Amendment C387 ggee to the Greater Geelong Planning Scheme

Landscape Architecture Evidence

Figure 6.1 - Interface 3: McDermott Road, North of Coriyule Road C - proposed interface to Properties 13 & 14

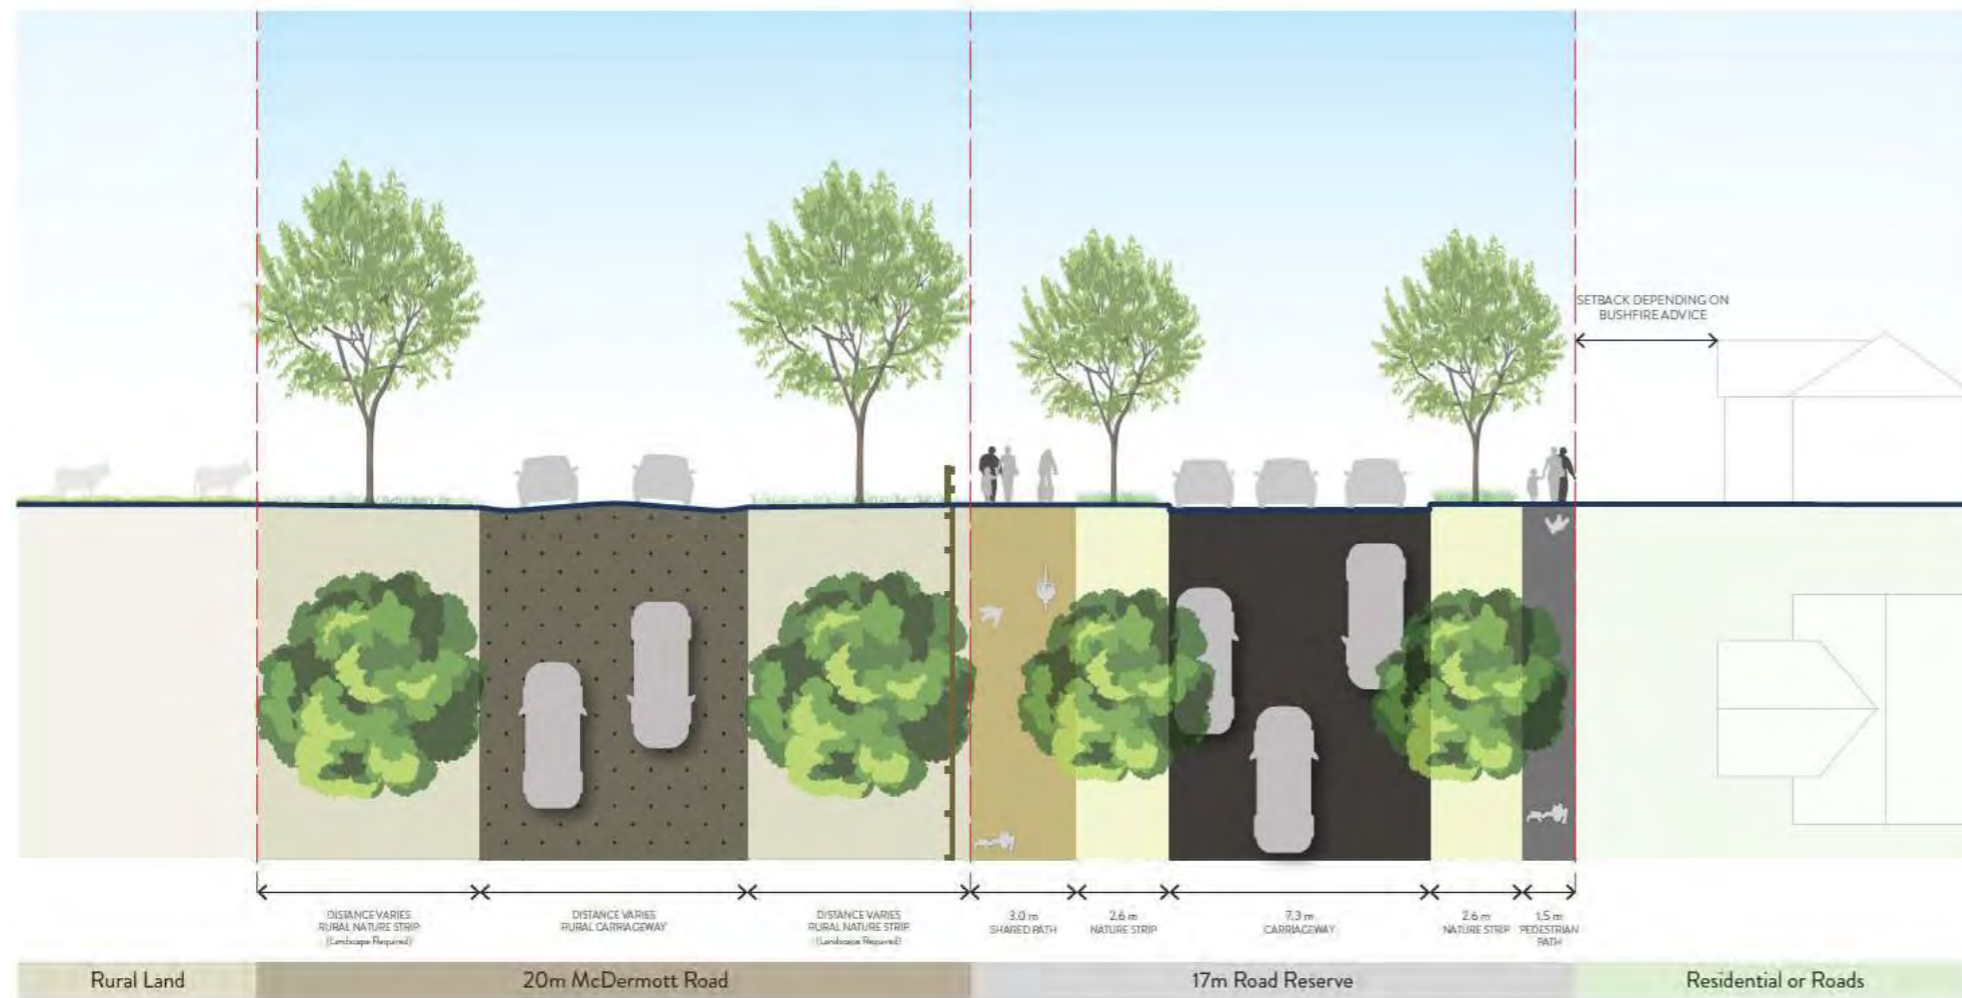
85. **DPO Schedule 46 Background Landscape Report (November 2022)** identifies the western boundary of Stockland's parcels as being "Interface 3: McDermott Road, North of Coriyule Road C". Figure 6.1 shows the proposed cross section for this interface, which assumes a 17m access street cross section with a 3m shared path on the boundary with McDermott Road.
86. Notwithstanding this cross section, Council's Consideration of Submissions report notes that "(t)here is also provision for any residential village that interfaces rural land to provide arrangements different to that shown in the DPO46 background landscape report." (p19 of 32.)

Figure 6.4 - Proposed McDermott Road cross section adjacent to Properties 13 & 14

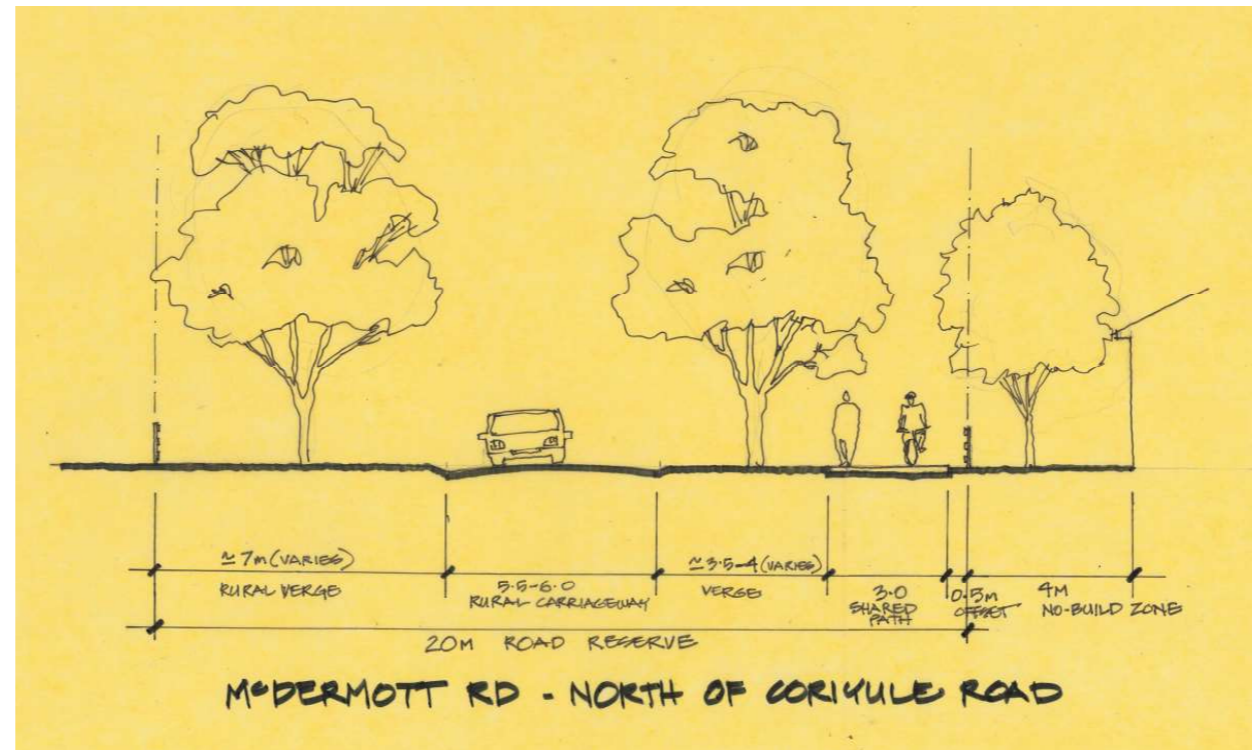
90. On site measurements indicate that the eastern verge varies between around 7 to 8+m and therefore, with a 3m shared path there would remain a verge of around 4m+ to accommodate substantial street trees as part of the creation of this low-key rural interface roadway. Stockland’s proposed “4 metre ‘no build zone’ for landscaping purposes” would accommodate a second row of trees within the Stockland land, reinforcing this low-key rural character. Figure 6.4 shows a simple sketch cross section of how this arrangement could work.

98. A rural road interface can be readily achieved with the location of the shared path along the eastern side of the generous 20m McDermott Road road reserve. Incorporation of the path will still accommodate the planting of substantial trees on both sides of the road. The proposed 4m 'no build zone' will allow the further reinforcement of this rural interface with additional substantial tree planting.
